April 2, 2021

Eric Sakotas
City of Aurora, Planning Department
15151 E. Alameda Parkway, 2nd Floor
Aurora, Colorado 80012

Re: Pre-Application Comments – Buckley Yard – Residential (#1518251)

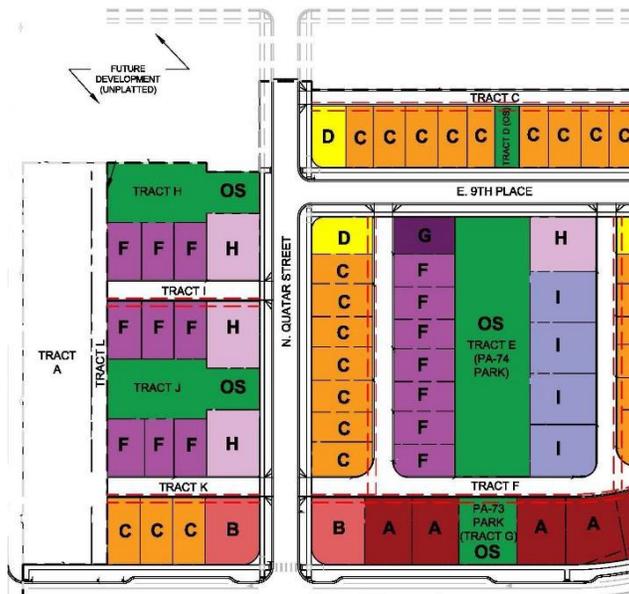
- Section 146-4.7.5 J. Building Perimeter Landscaping

Building perimeter landscaping is required for all single-family attached (townhome) residential dwellings.

Plant beds shall be an average of six feet wide and shall consist of 1.25 plants per five linear feet of unit perimeter footage. At least 5% should be a mixture of evergreen and deciduous trees, at least 15% shall be tall shrubs with a mature height of 6' and up to 80% shall be a mixture of evergreen and deciduous shrubs chosen to create seasonal interest. An example table demonstrating compliance has been provided below.

Response: Noted, thank you.
